PROFESSIONAL RECOMMENDATION MEMORANDUM

Project Name: Engineering Support Services and Recommendations for Roadside Safety Issues/Problems for Member States

Task 22-16: Illinois Transition Angle for 2-Tube Bridge Rail Thrie Beam Transition

DATE: December 16, 2022

Figure 1. Comparison of Bridge Rail Connection Details

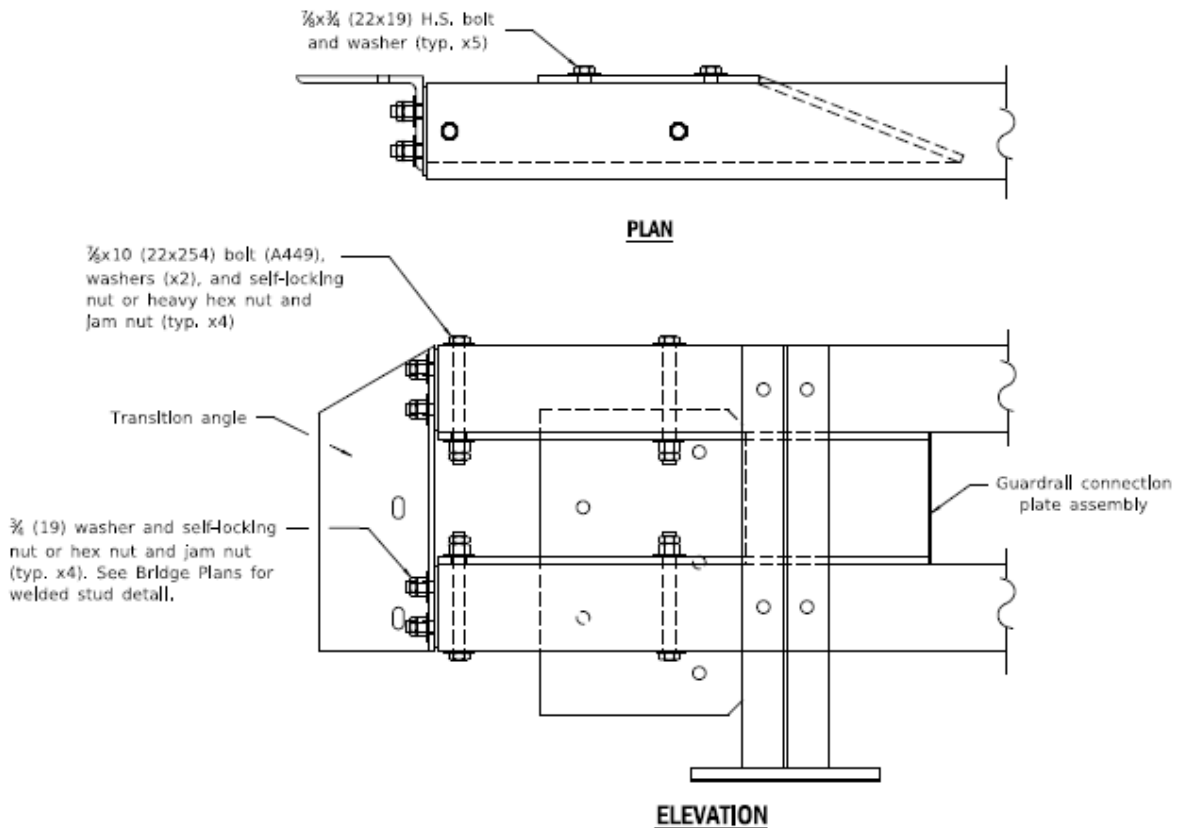
The 2-tube bridge rail thrie beam transition with a transition angle of 5/16" thickness was previously crash tested by TTI (TTI Project 608331-4-6 ^[1]) and passed safety evaluation criteria for the MASH TL-3 ^[2]. Illinois DOT has used a transition angle thickness of 7/16" for a similar thrie beam transition system (Standard 631066). As shown in Figure 1, the bridge rail connection details of TTI crash tested and Standard 631066 are very similar but different in size and thickness. TTI researchers understand that Illinois DOT would prefer to use a L8"x6"x1/2" thick angle instead of the L5"x5"x5/16" thickness that was crash tested under TTI Project 608331-4-6. For this project, TTI researchers investigated the adequacy of two options for implementing a thicker transition angle in a 2-tube bridge rail thrie beam transition at the request of Illinois DOT. TTI researchers focused on this transition angle only, and other details of bridge rail transition connection are outside the scope of this professional opinion.

Figure 2. Comparison of Transition Angles

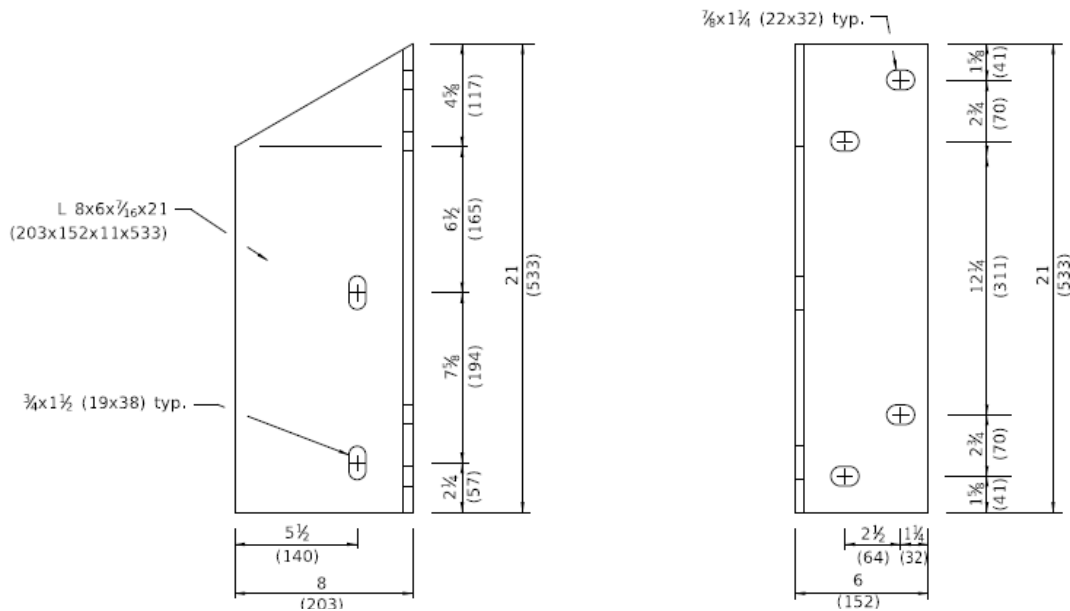
Figure 2 compares the (a) TTI crash tested and (b) Illinois DOT standard transition angles. As shown in the figure, while TTI crash-tested transition connection angle is made of L5"x5"x5/16" angle, the Illinois DOT Standard 631066 currently uses L8"x6"x7/16" but it is preferred to use a

1/2" thickness for better availability. The TTI researchers believe the use of larger angle size will not adversely affect the crash performance of the transition design. It is recommended that the same 60-degree angle slope be used for the L8"x6"x7/16" angle size. With this larger angle size and same top slope, it is our opinion that this proposed angle size is acceptable for MASH TL-3 criteria.

Figure 3. Change of hole location

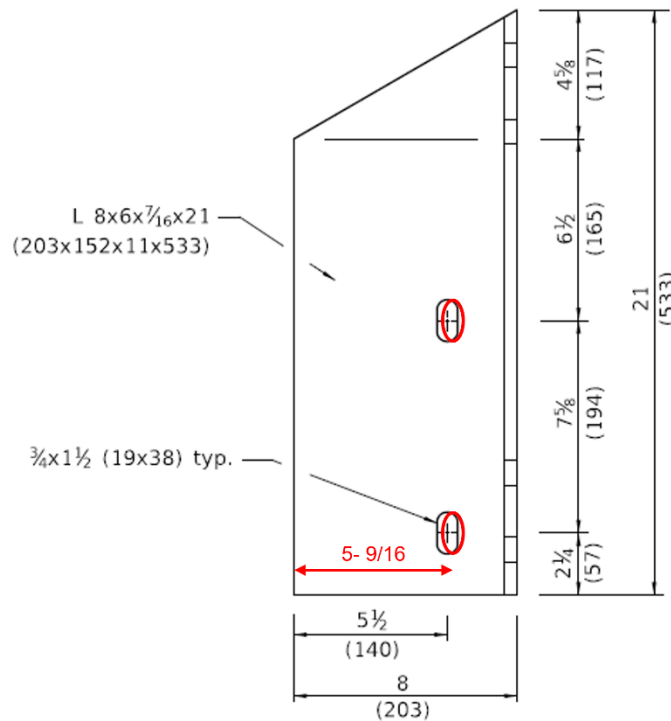
- 1) Change the location of the two $\frac{3}{4}$ " x $1\frac{1}{2}$ " holes (from the outer surface) from $5\frac{1}{2}$ " to $5\frac{9}{16}$ " to secure more space to accommodate the $\frac{5}{8}$ " bolt while reducing interference with other bolts.
- 2) Use an open-end wrench instead of a socket wrench to avoid too many chain reaction changes to our base sheets while maintaining the hole location.

Option 1: Figure 3 shows a transition angle considering the change in the location of the hole for the bolt. As shown in the figure, the location of the hole is only $\frac{1}{16}$ " away from the original location. This is a minor change. It is our opinion that such a slight change will not affect the structural performance of the angle. This location still is within tolerance of AISC requirements regarding the minimum edge distance and spacing ($\frac{7}{8}$ " for $\frac{5}{8}$ " bolt, AISC Table J3.4 [3]). Thus, the change of hole locations is considered acceptable with respect to AISC connecting requirements.

Figure 4. Transition angle details with bolts

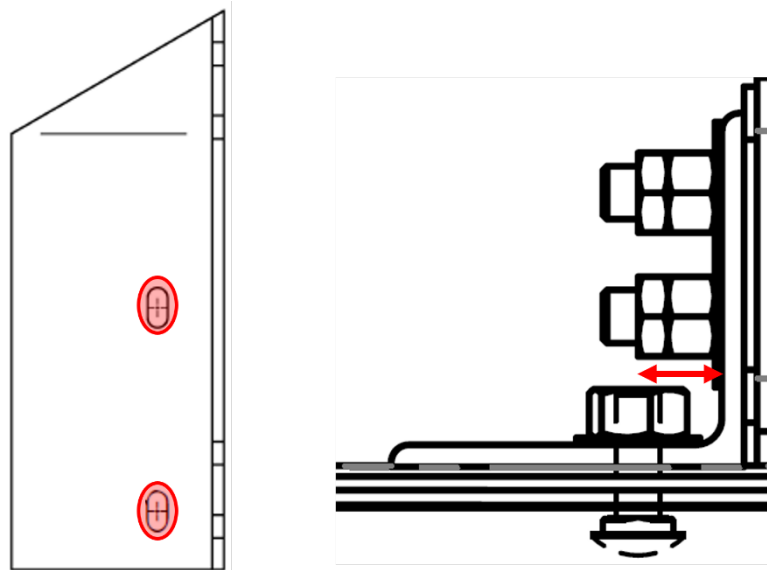
Option 2: Figure 4 shows transition angle details with $\frac{3}{4}$ -inch diameter bolts. As shown, both upper and lower connection bolts will likely have a tight connection tolerance due to the increased angle thickness. Please see the location of bolt holes shown in red below. The use of a socket

wrench will likely not be possible for both bolts. To facilitate making this connection, an open-end wrench can be used in lieu of a socket wrench. If an open-end wrench is used, it is recommended that sufficient tightening torque is used for both tightening options.
